RE: Follow-Up: request for Additional Information RE: Valmet, Inc. Letter dated September 3, 2015

The attached page is in response to your request dated September 28, 2015 for additional information concerning our amendment request of September 3, 2015. This document provides the labeling to be used on the PaperLab Multi-Filler Module, NR-0596-D-114-G.

PaperLab Filler Module Labels: NR-0596-D-114-G

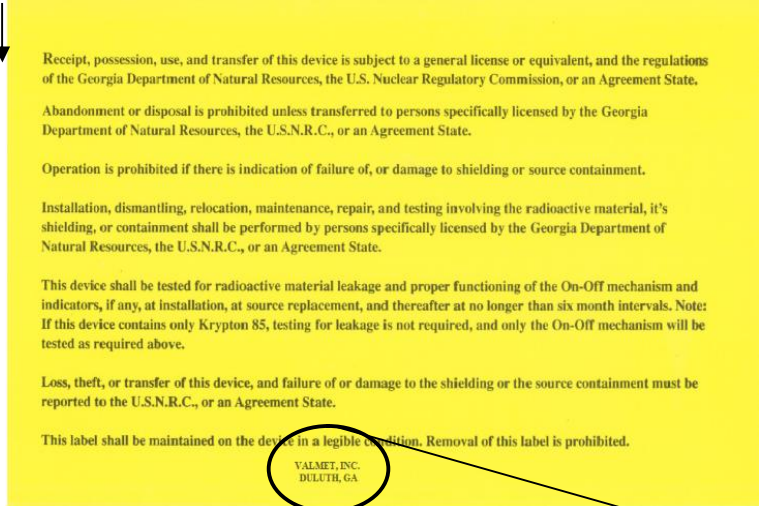
The Labels will be the same material and size as the Metso labels. The only difference is that they will identify Valmet as the manufacturer and/or distributor.

Device ID Label - Valmet

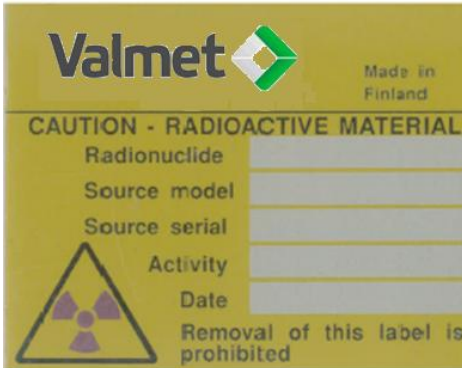
GL Rules & Regs Label

Source ID label - Valmet

The labels will be located on the device as shown.
